## **Tahmoor Colliery**

# **AMENDMENT TO NATURAL FEATURES SURFACE SAFETY AND SERVICEABILITY MANAGEMENT PLAN (REVISION H)**

## **DUE TO THE MINING OF LONGWALL 26**

**February 2011**

**Fig. 1.1 Aerial Photograph overlaid with previous and current Mine Plan**

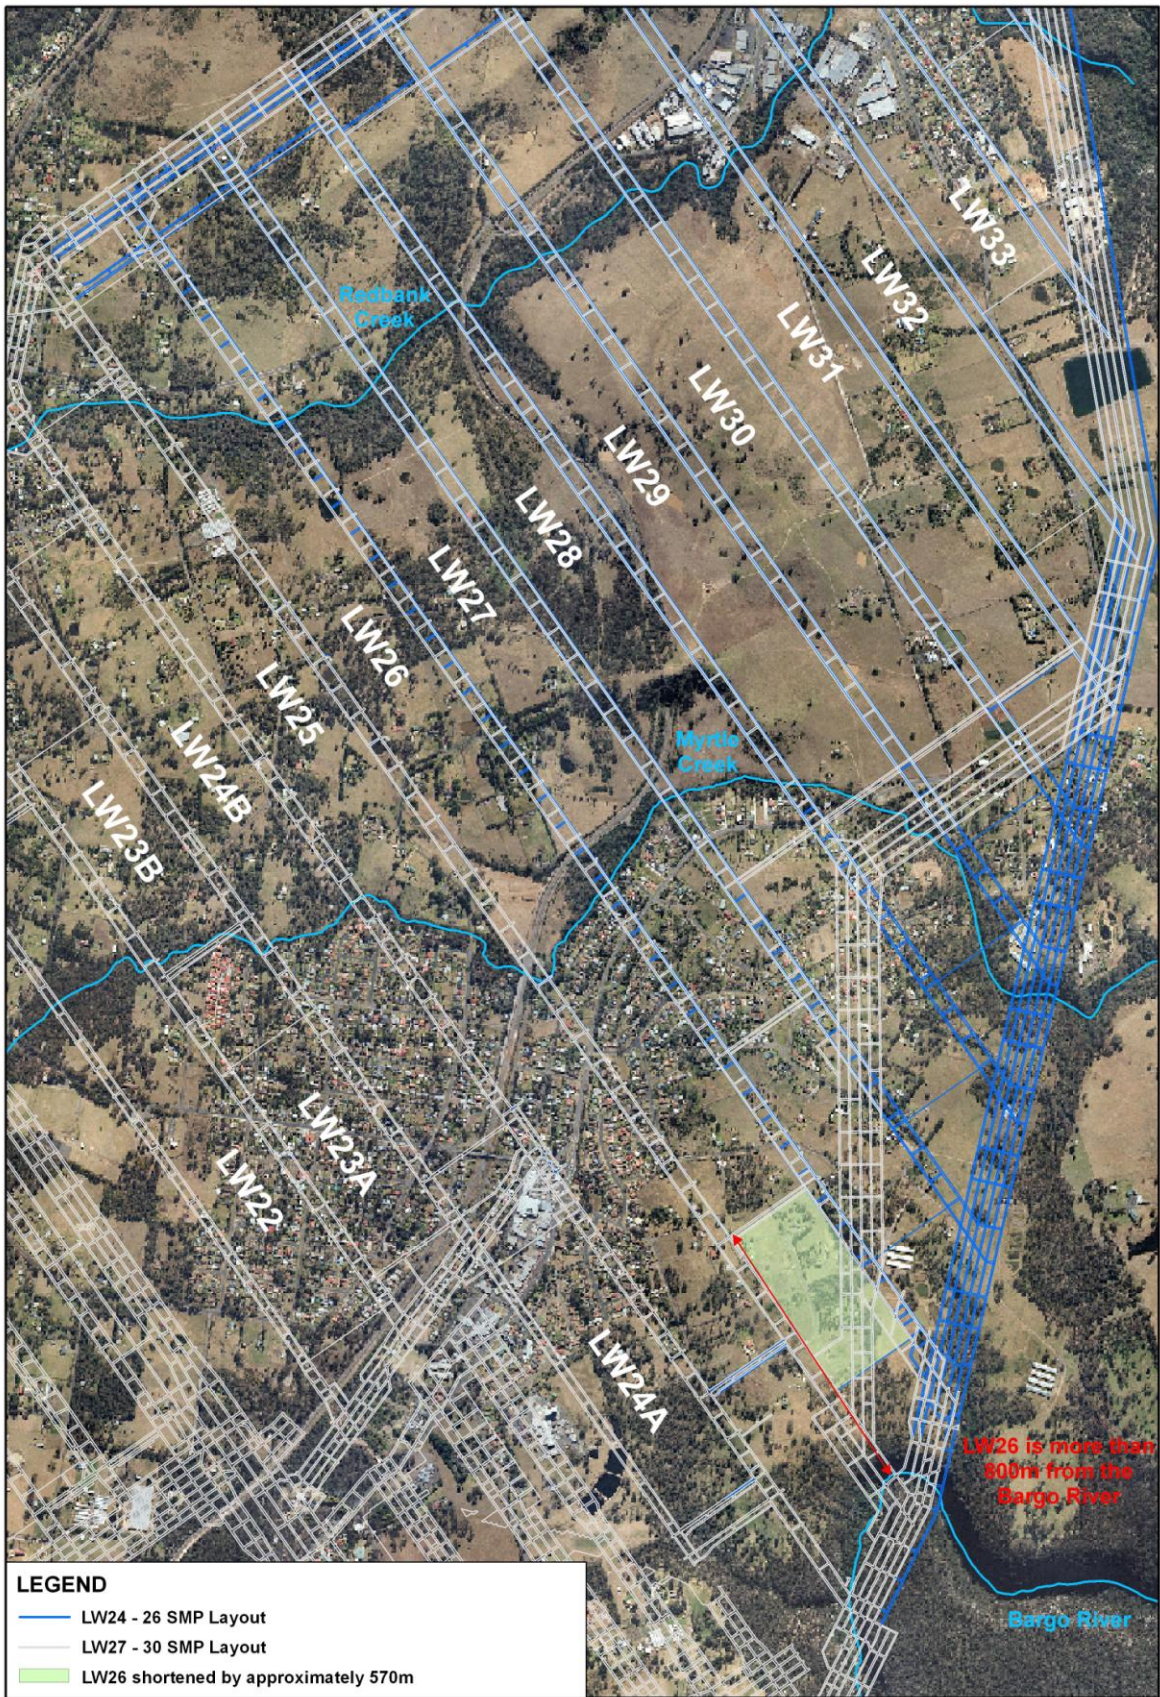
This document amends the previous Management Plan (Rev. K). When compared to the previous Plan, the amended management measures in relation to the Bargo River have been reduced. The Plan has been amended because the current layout for Longwall 26 has been significantly shortened by approximately 571 metres compared to its previous layout. It is also noted that no impacts and minimal subsidence, valley closure and upsidence movements were observed during the mining of previous Longwalls 24A and 25, which extracted closer to the River.

The Bargo River is located more than 800 metres from Longwall 26, at the closest point. An aerial photograph, overlaid with the mine plan and predicted limit of subsidence is shown in Fig. 1.1.
